City of Bartlett

Municipal Planning Commission

1. The Sanctuary Subdivision, 3465 Kirby Whitten Parkway, (Keith Grant, BlueSky Communities, Inc.)

2. The Sanctuary Subdivision Phase I, 3465 Kirby Whitten Parkway, (Keith Grant, BlueSky Communities, Inc.)

MASTER PLAN
LOT LAYOUT
THE SANCTUARY
BARTLETT, TENNESSEE

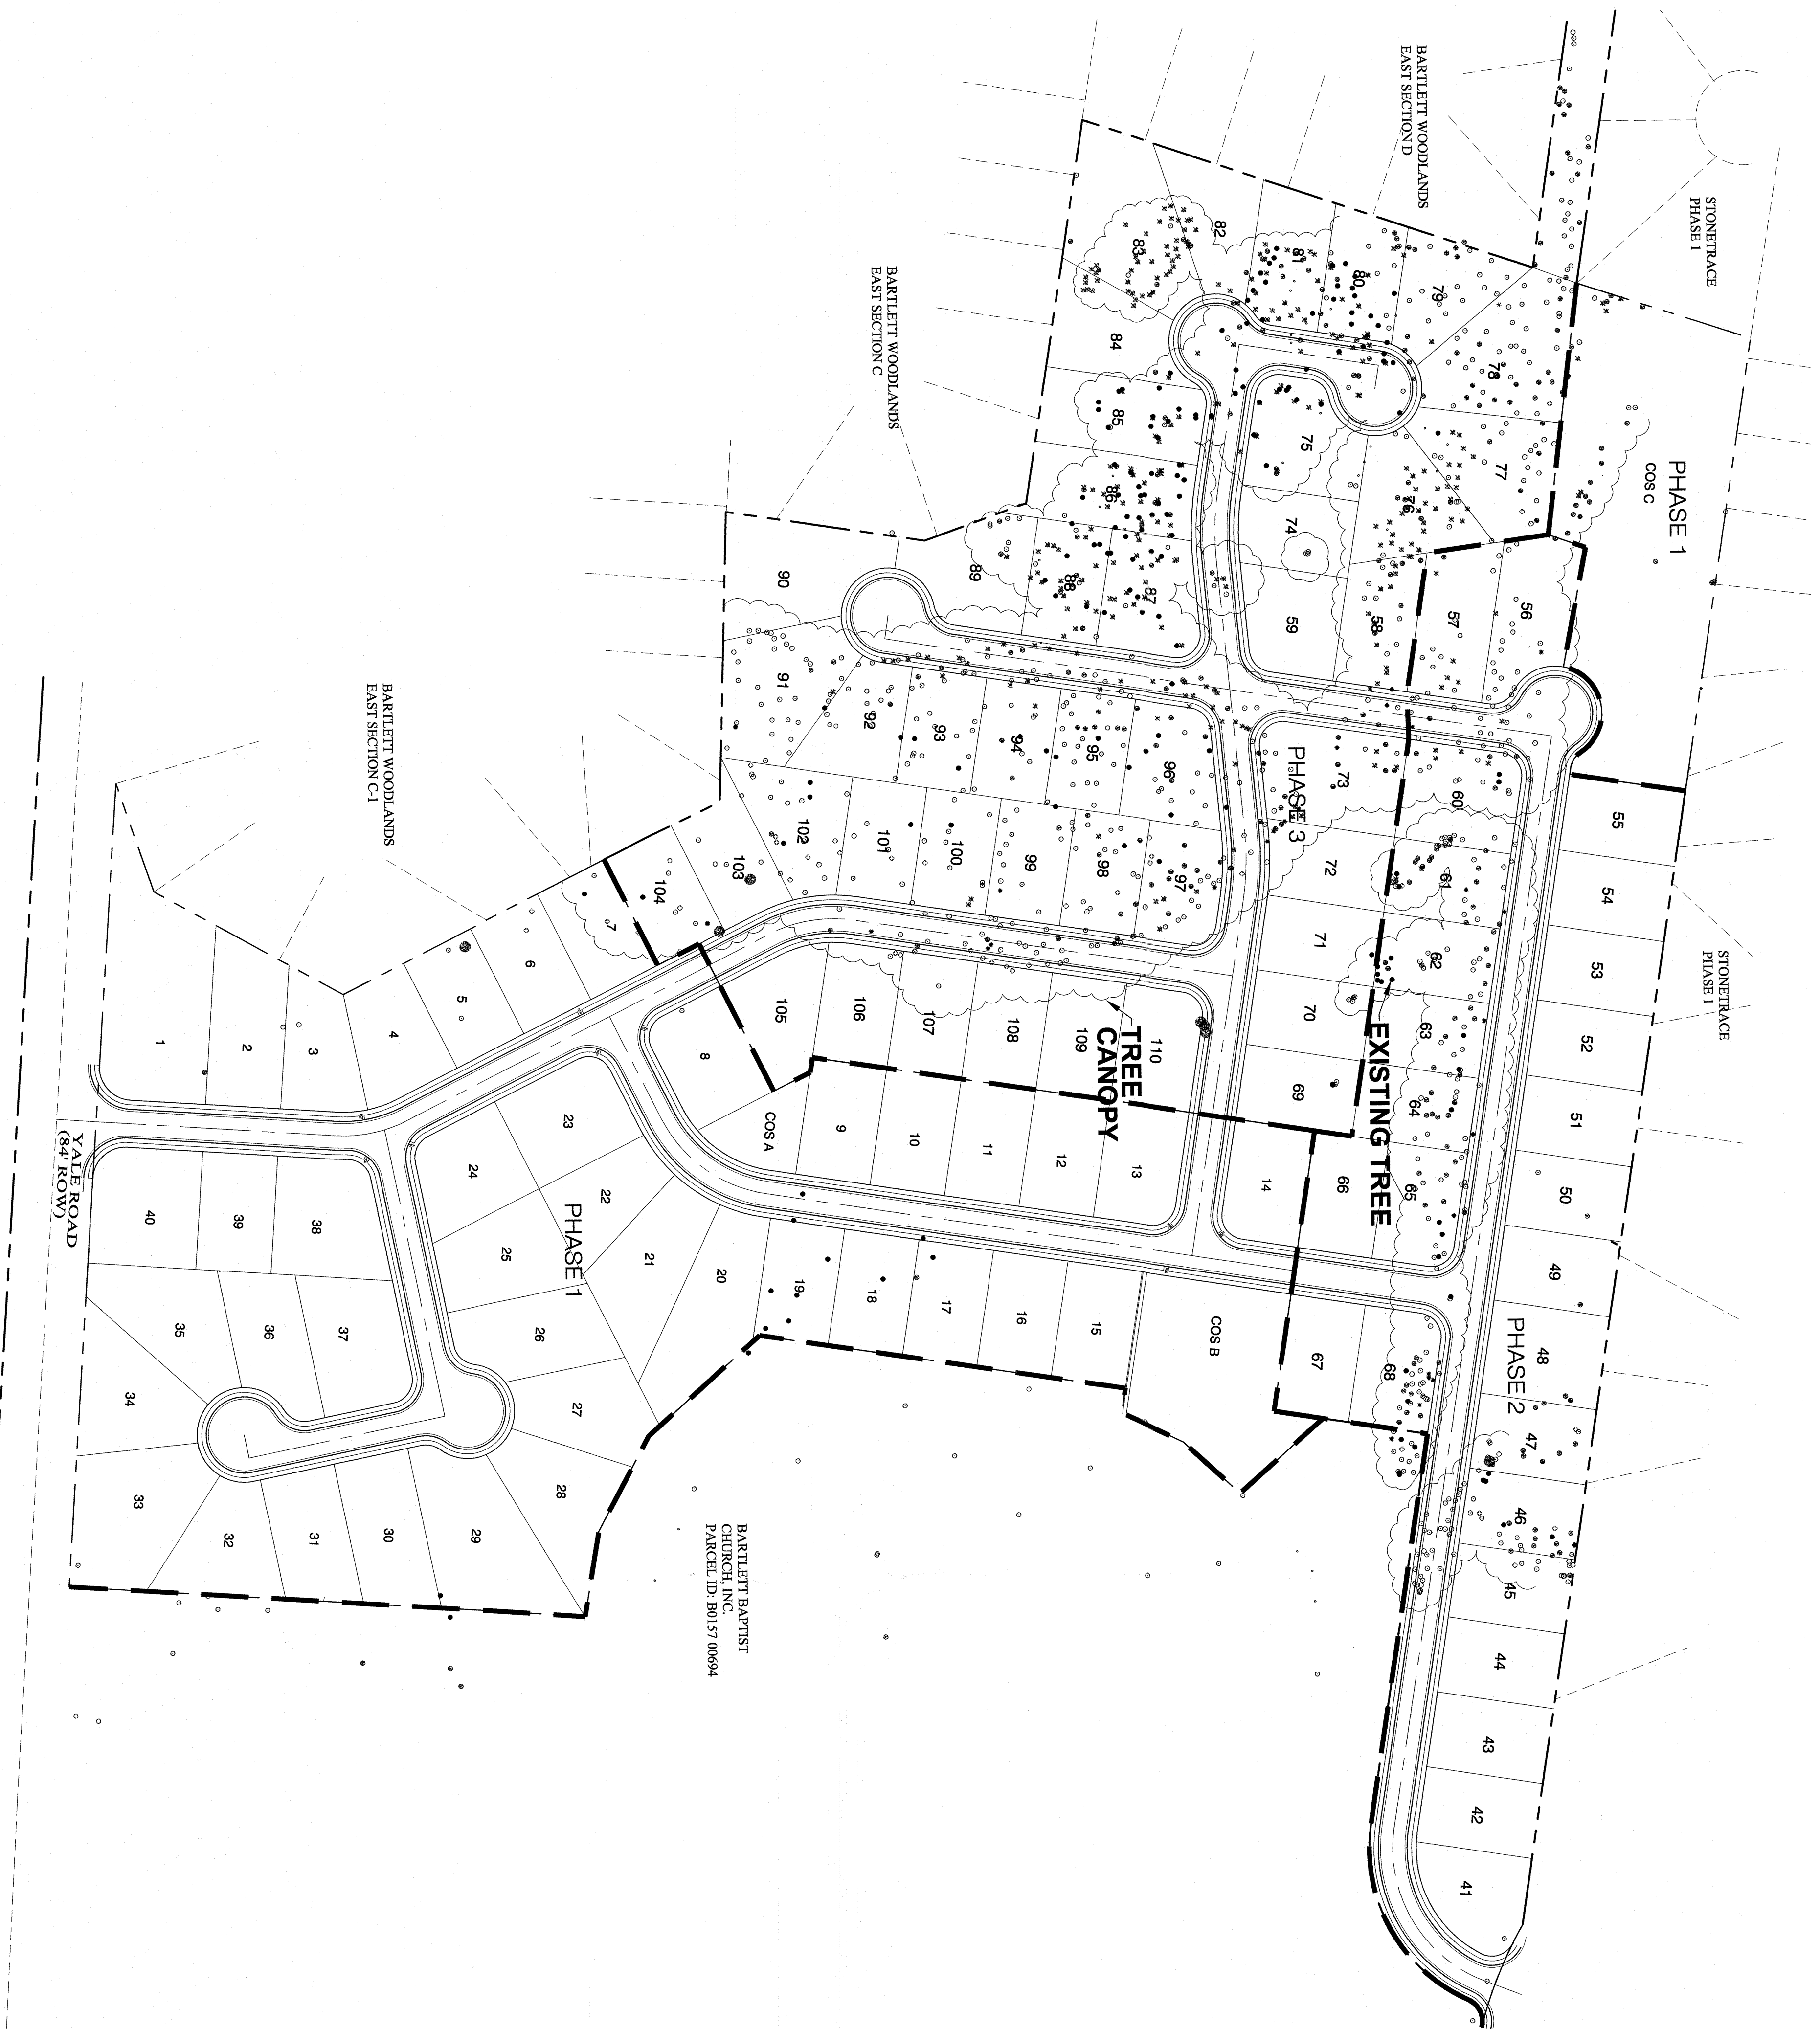
3. The applicant will need to add a note to the plat to deny driveway access to Yale Road for lots 1, 40, 33, 34, 35.
4. The applicant shall identify the location for the Post Office required cluster box to the final plat.

5. The applicant shall revise the vicinity map to show correct street locations.
6. The applicant shall designate and show a 5-foot utility easement along all property lines.

7. The applicant shall indicate who owns and will maintain the grassy strip of property between Lot 78 and the Altruria Frontage on the final plan/plat.

MASTER PLAN
SANITARY SEWER PLAN
THE SANCTUARY
BARTLETT, TENNESSEE

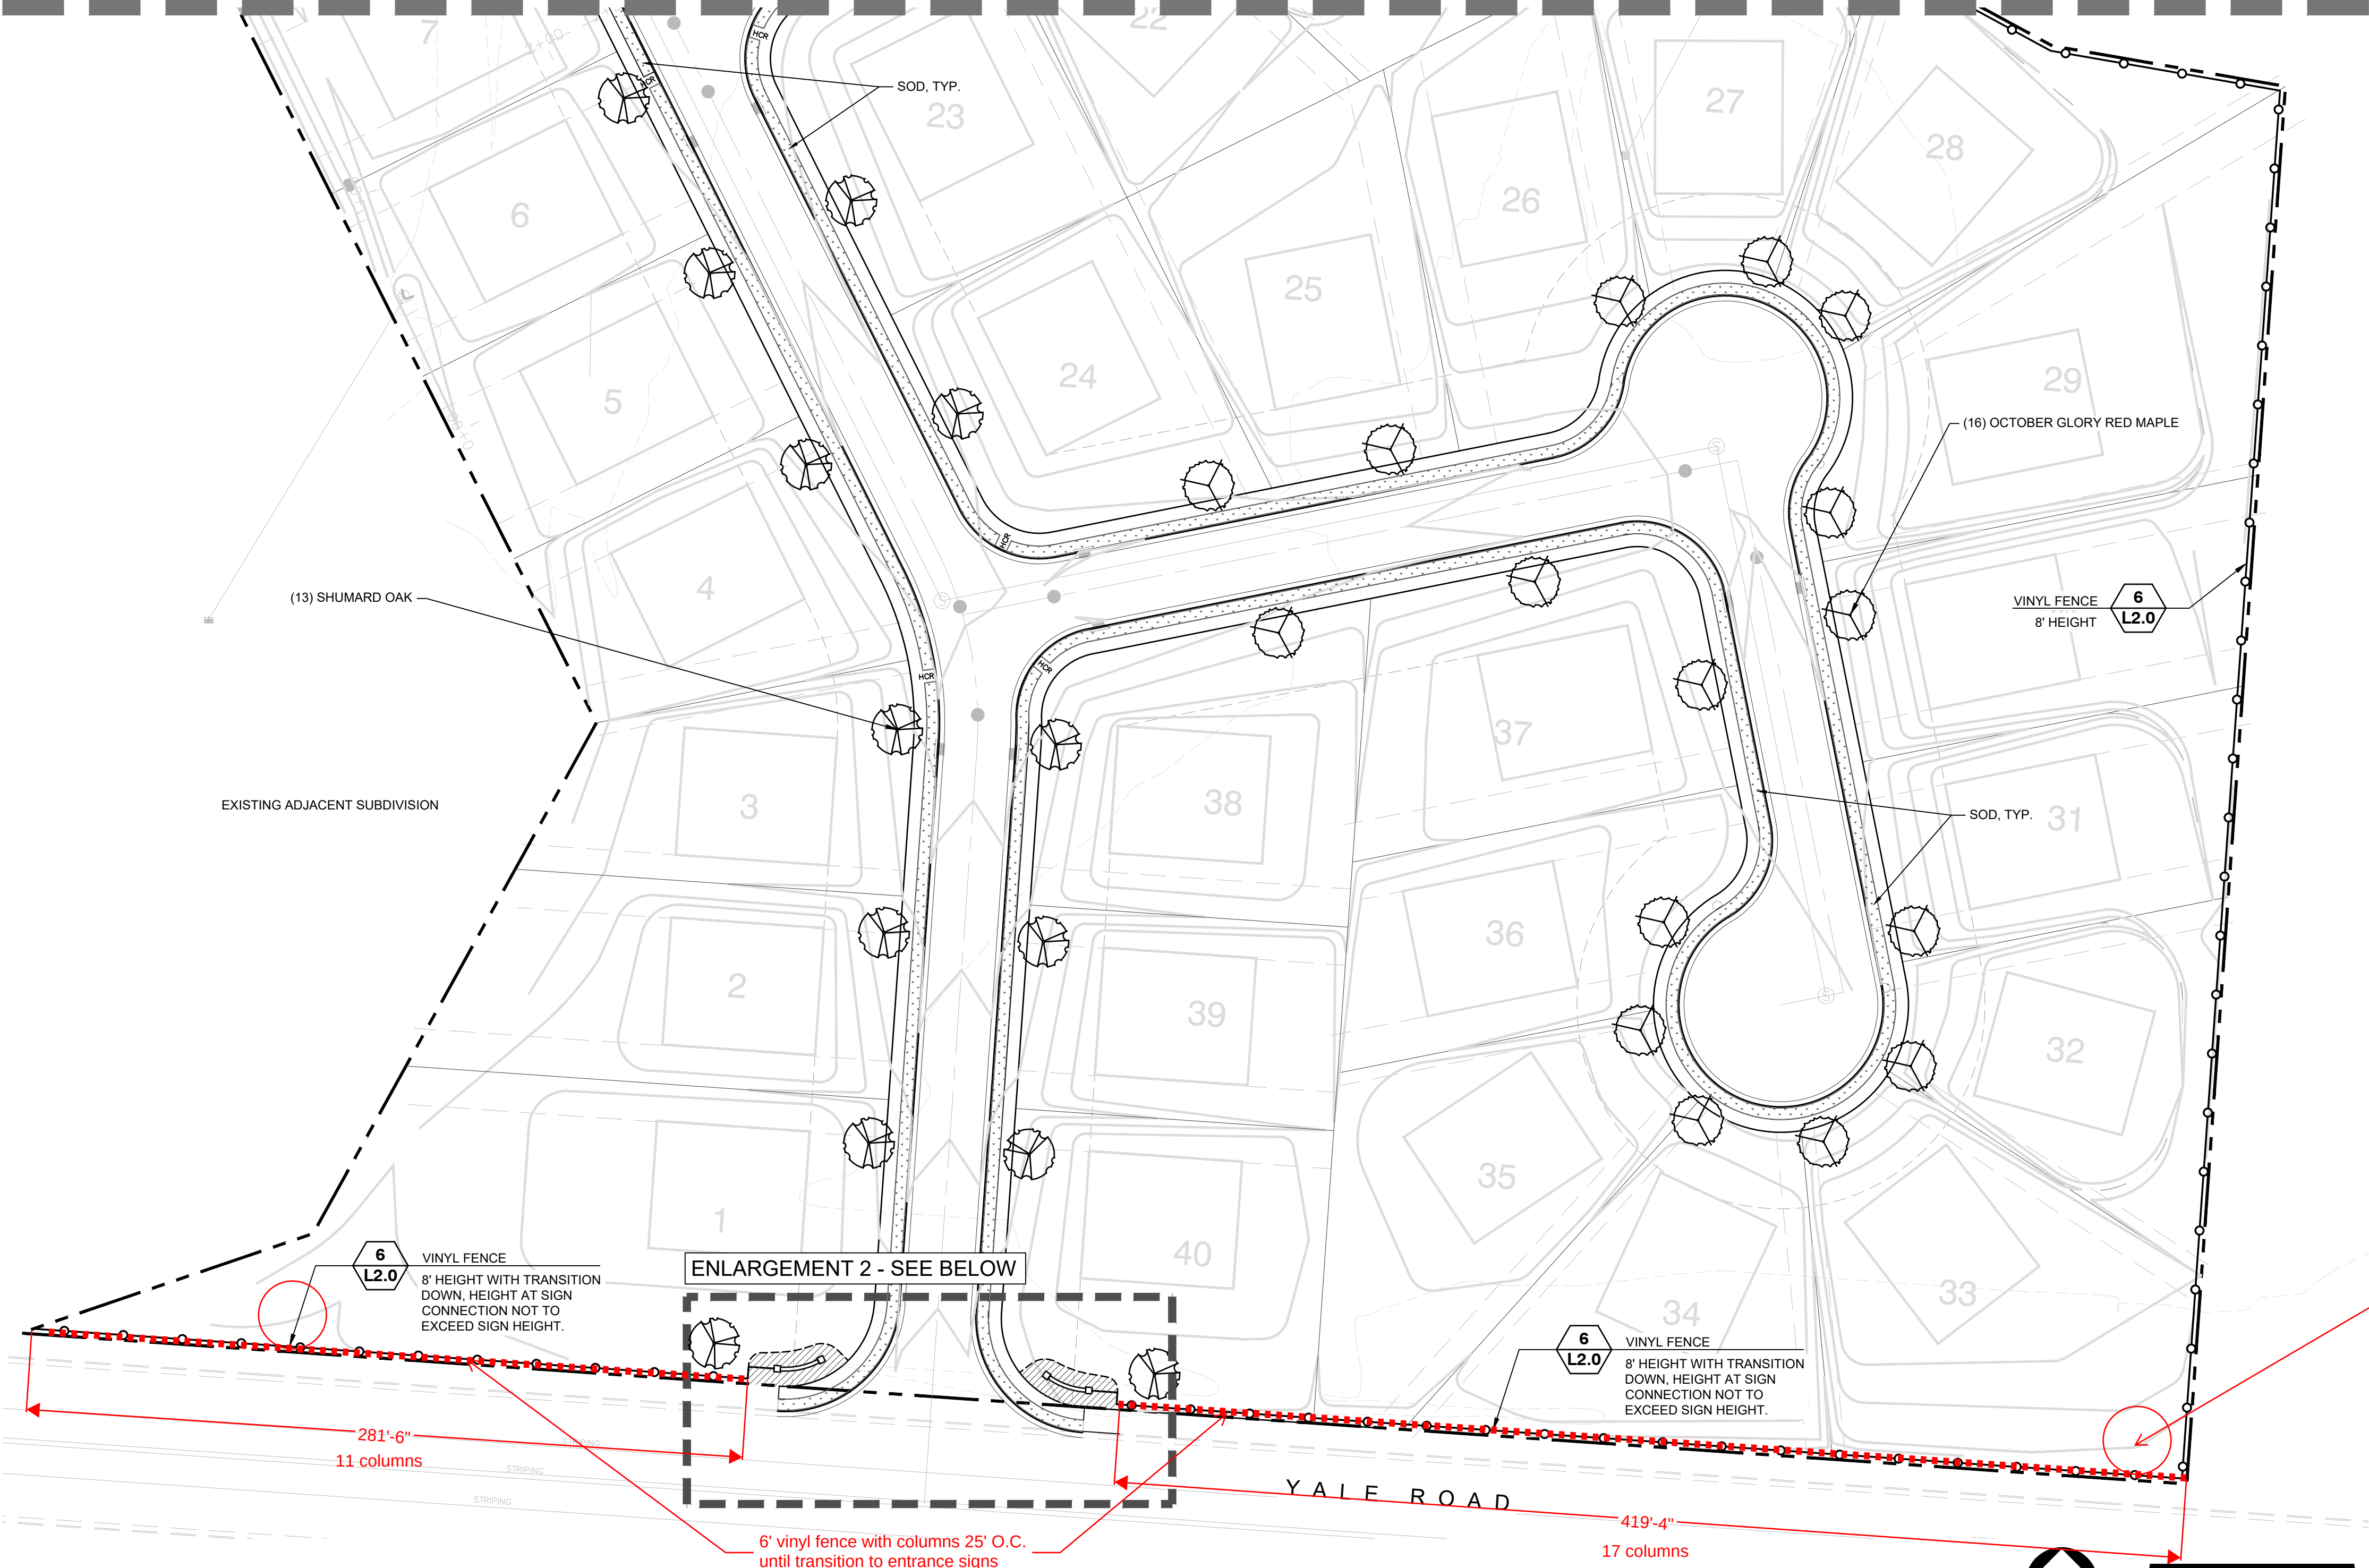
- 9) The following will be required regarding the Existing Sewer shown to be removed: Once sewer pipe is removed, all trenches shall be backfilled and compacted to 98% Standard Proctor.
